**Comments of NGIV2, LLC on  
September 25, 2019 Stakeholder meeting  
2019-2020 Transmission Planning Process (“TPP”)  
October 10, 2019**

**Figure 2: Path 26 Congestion due to PDCI**

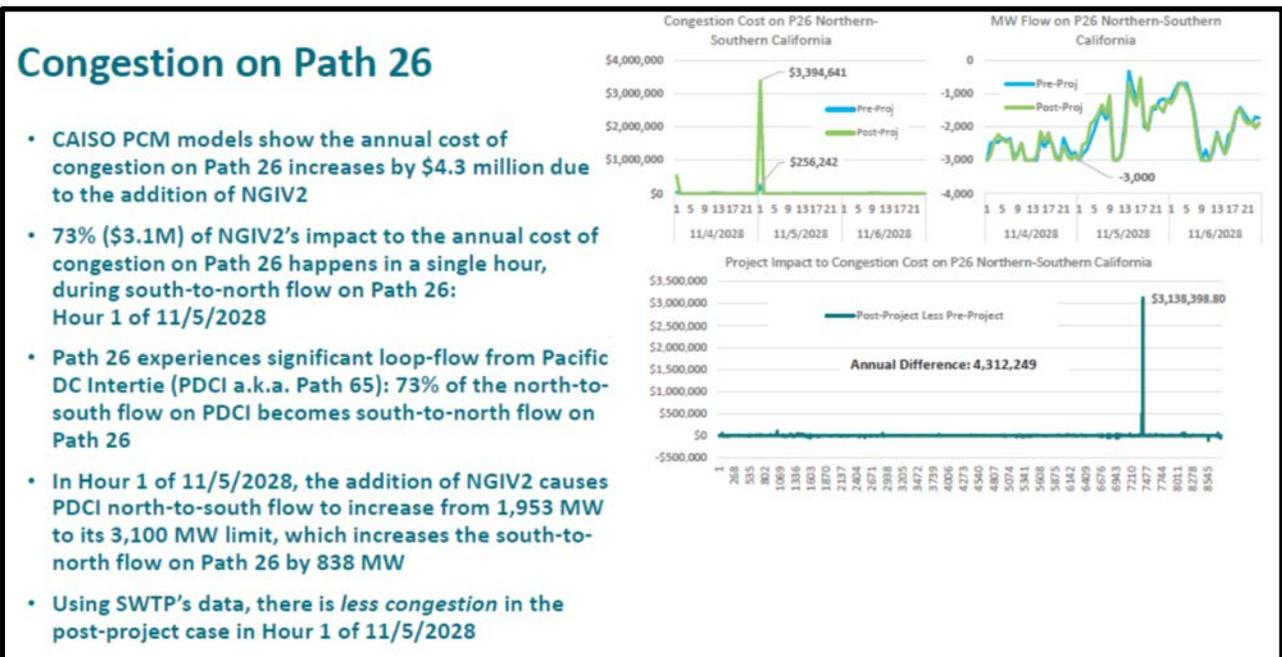
Path 26 Congestion: NGIV2 has performed an independent economic analysis to benchmark the CAISO 2018-2019 Economic Assessment results (pre and post NGIV2). In addition to the errors in the modeling of NGIV2 (and the incremental capacity to Path 46), we were able to identify the specific areas of congestion that we believe should be examined for the 2019-2020 assessment with the NGIV2 Project. As shown in Figure 2, the majority (73%) of the Path 26 congestion reported in the assessment is attributed to a single hour (Hour 1, 11/5/2028) where the PDCI maxed out for that one hour (N to S), and forced the Path 26 to hit a limit S to N. This points to an issue within GridView and modeling of HVDC systems that we have discussed before.

**Figure 3: Congestion comparison with CAISO vs NGIV2 model**

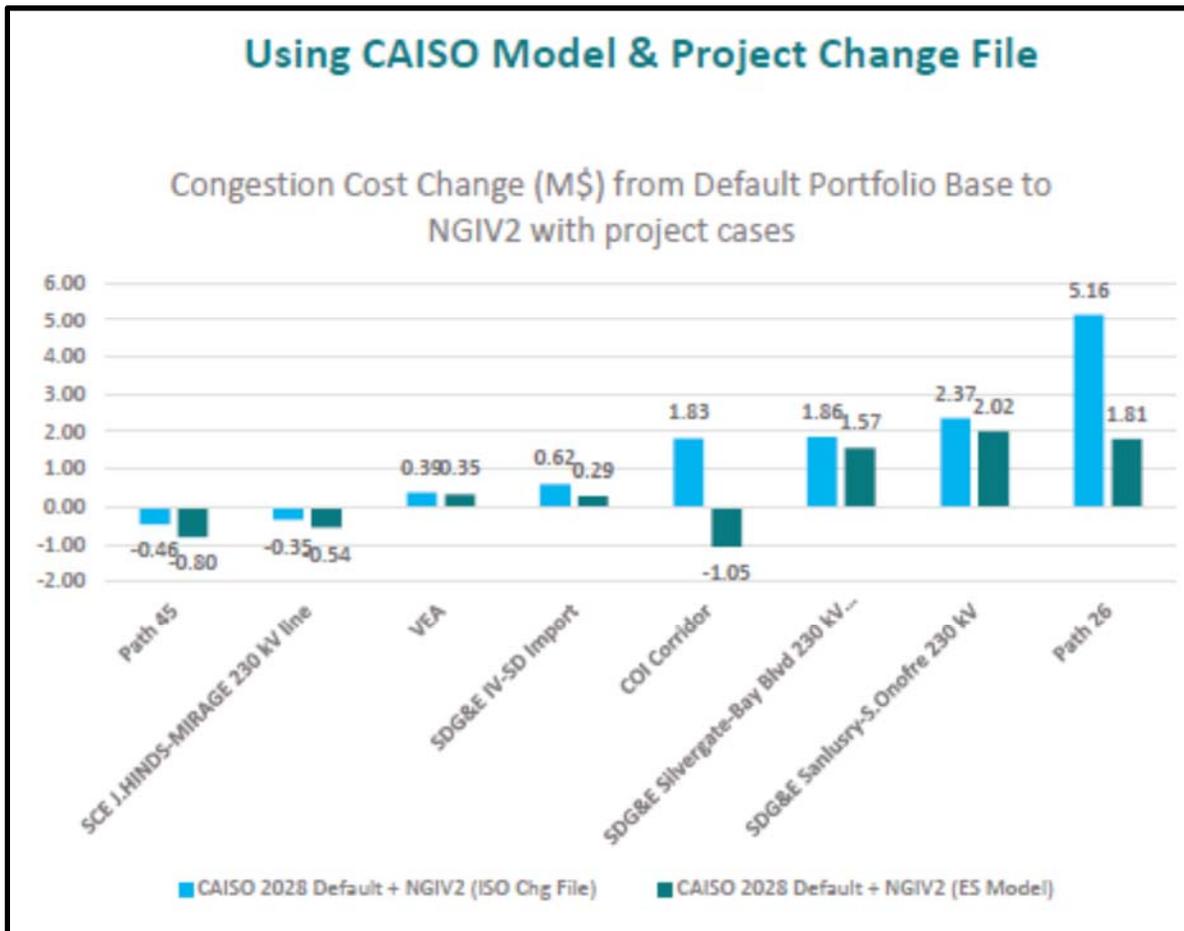
Other Reported Congestion: While comparing the NGIV2 benchmarked economic model from the 2018-2019 assessment and the accurate NGIV2 model recently completed, several of the congestion costs reported in the 2018-2019 assessment are less of an impact than noted or in some cases, including COI, the NGIV2 Project actually reduces congestion instead of increasing congestion. Please refer to Figure 3 for a comparison of the reported congestion impacts due to the NGIV2 Project.

Because of the discrepancies in this comparative analysis, NGIV2 requests additional transparency while conducting the 2019-2020 economic analysis, including: continued discussions with those that have submitted projects earlier in the process with preliminary findings, providing raw output files to assist in identifying data anomalies similar to the error with PDCI causing congestion on Path 26, and communicating enough to reach a
